NOTICE OF DECISION

ADMINISTRATIVE SITE DEVELOPMENT PERMIT GILMAN POINT

APPLICATION NO: ASDP15-00002

Project name: Gilman Point

1 FRONT ELEVATION/SOUTHEAST
SCALE: 1/8" = 1'-0"

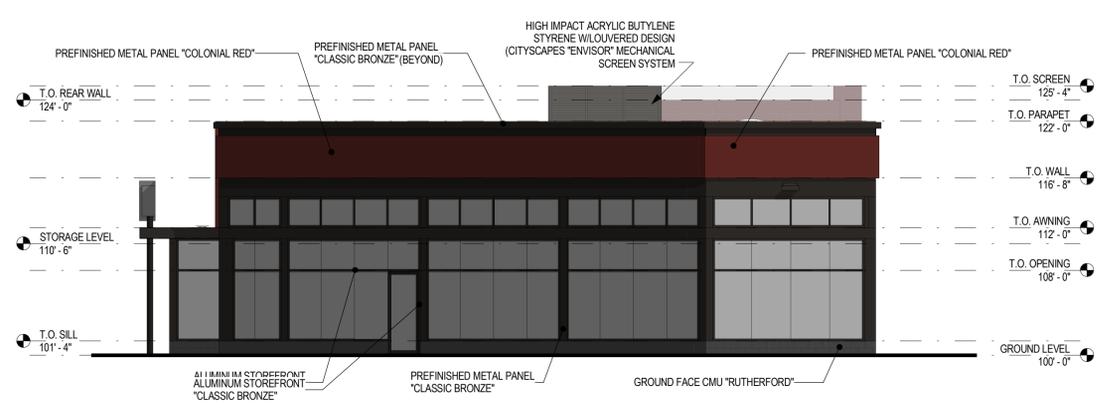
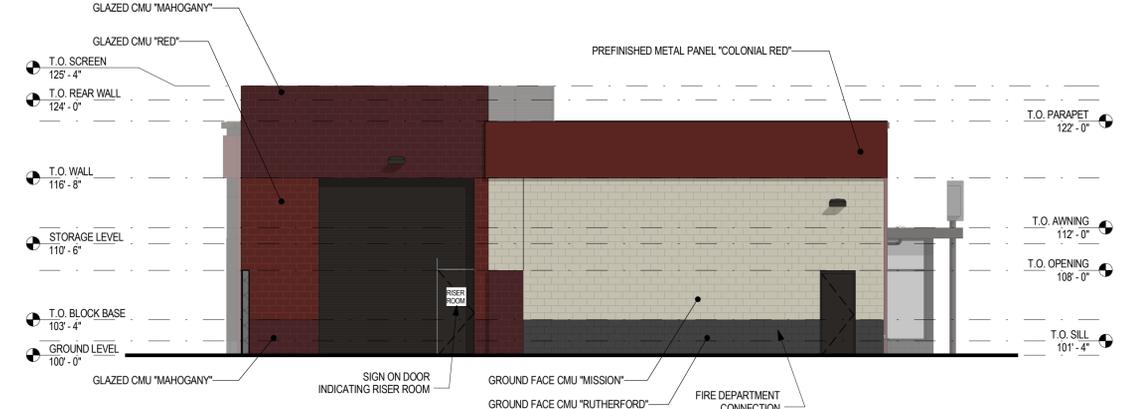
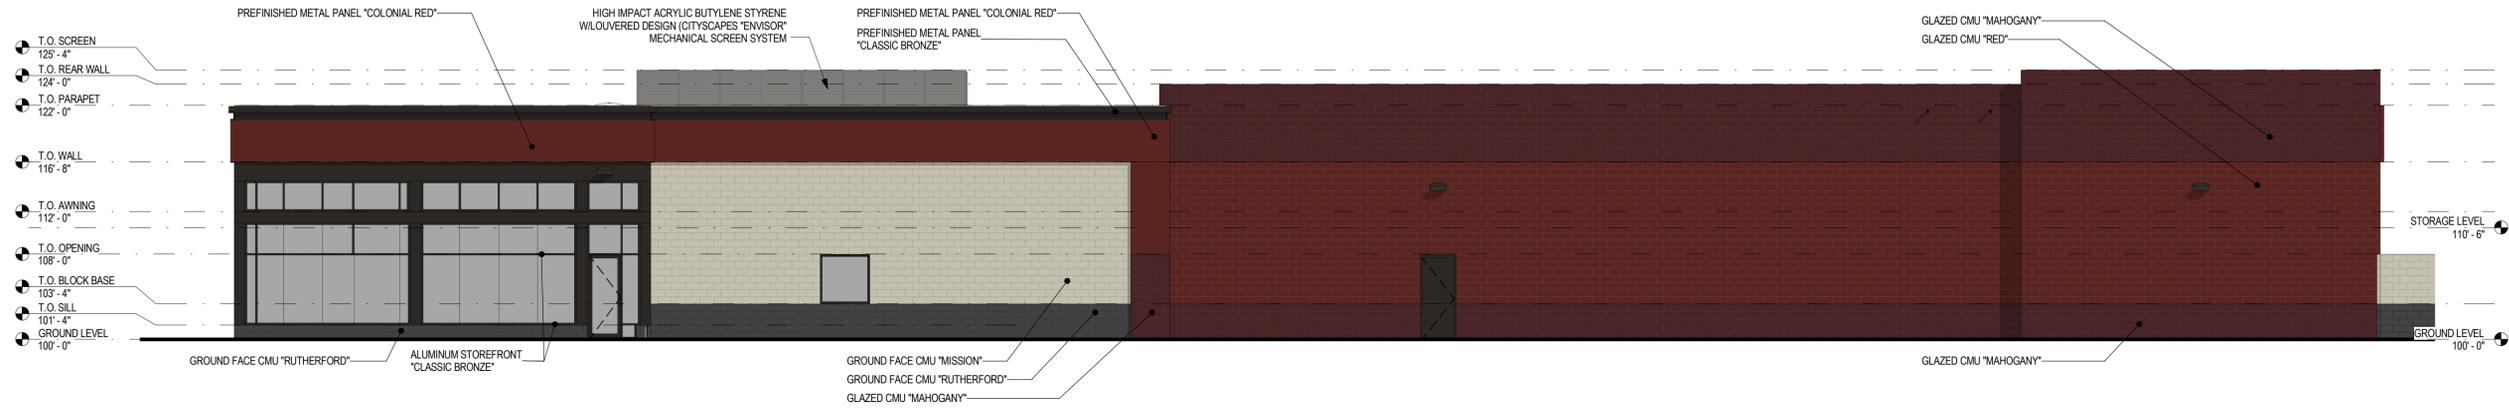
14.2.B	Blank walls			X		<p>Tire Facility Building Elevations - Sheet AB3.1</p> <ol style="list-style-type: none"> 1. Front elevation (southeast) – complies 2. Showroom elevation (southwest) – complies 3. Loading elevation (northeast) – complies 4. Rear elevation (northwest) – does not comply <p>The rear elevation appears very blank in nature and is designed as the “back” of the building. Per Section 14.2.A, “Generally, buildings should have no “back side”. As such, additional wall treatments and detailing are necessary for this wall. Design alternatives include, but are not limited to: piers, modulation, varied materials and detailing, trellises, applied elements and art. See Condition 20.</p> <p>Sheet A3.2 (wing wall extension for loading area)</p>	<p>Condition 20: The rear (east) elevation of the tire facility (including the wing wall extension for the loading area) shall incorporate additional wall treatments, including but not limited to canopies, building modulation and detailing, varied materials and textures, applied elements, trellises, etc., in order to reduce its blank appearance.</p> <p>Condition 21: The following walls of the storage facility shall incorporate additional wall treatments, including but not limited to canopies, building modulation and detailing, varied materials and</p>

CIDDS Standard #	Name	Not Appl.	Meets Standard?		Review At Constn.	Staff Analysis	Conditions of Approval
			Yes	No			
						<p>The screen wall that extends beyond the corner of the loading area is very blank in nature. Given its adjacency to the neighboring restaurant, this wall will have a prominent presence and shall be treated using the techniques identified above in order to minimize its presence when viewed from offsite.</p> <p>Storage Facility Revised Building Elevations – Sheet A3.1, A3.2 (Attachment 7)</p> <p><u>South elevation</u> – The storefront and upper levels of the building meet the standard by providing windows and wall detailing which serve to break up the presence of blank walls.</p> <p>The section of wall underneath the building overhang (facing parking lot) has acceptable variation near the retail store entrance and where the overhead garage doors are located. The middle section, however, shows long expanse of blank wall, broken up only by an automatic sliding glass door. <u>This wall qualifies as a blank wall and additional treatment is required.</u></p> <p><u>West elevation</u> – The west elevation faces the East Lake Sammamish Trail, a key pedestrian circulation facility. As such, its design shall correlate with the trail appropriately.</p> <p>In general, the wall provides an inadequate level of detailing to break up the walls blank appearance, especially the middle section between the retail store front and the bay of windows near the back.</p>	<p>textures, applied elements, trellises, etc., in order to reduce its blank appearance:</p> <ol style="list-style-type: none"> 1. Wall on south elevation, underneath building overhang between the retail store entrance and the overhead garage doors; 2. West elevation: the untreated wall section between and above the retail store front and the tri-color block wall located at the back of the building; 3. North elevation: the north wall elevation shall be designed with dark, muted tones and materials in order to reduce its visibility from off-site. 4. East elevation: the east wall elevation shall be designed with colors and materials to achieve balance between the presence of the rear of the building with the lush landscape that is present along Interstate 90. This includes the addition of varied color blocking, modulation or other techniques that serve to partially obscure the wall while still making it attractive to vehicles traveling at freeway speeds.

CIDDS Standard #	Name	Not Appl.	Meets Standard?		Review At Constn.	Staff Analysis	Conditions of Approval
			Yes	No			
						<p>Given the walls adjacency to the East Lake Sammamish Trail, three of the larger panels of wall (identified below) appear very blank, showing only small horizontal panels to break up the single plane/finish wall section. These wall sections will require additional treatment in order to reduce their blank presence.</p> <p>Sheet A3.2 <u>North Elevation</u> – The north wall is located on the back of the building and faces Interstate 90 (and to a lesser extent, the East Lake Sammamish Trail). In general, the wall appears very blank except for a bank of windows located on the NE side of the elevation. These windows would be more appropriately suited for the west side of the wall as this portion will be more visible from the East Lake Sammamish Trail.</p> <p>As part of the wetland mitigation for the project, approximately 11 evergreen trees will be planted in front of the northeast portion of the wall and this will help to further screen the wall from view. Additionally, there is also a grove of trees located within the WSDOT right-of-way between the interstate and the property which will provide effective screening as viewed from the interstate.</p> <p>Because this wall does not front onto a primary circulation facility, the primary design focus should be to obscure the wall from view of vehicles on Interstate 90. Dark, muted tones and wall detailing should be used to limit its presence.</p>
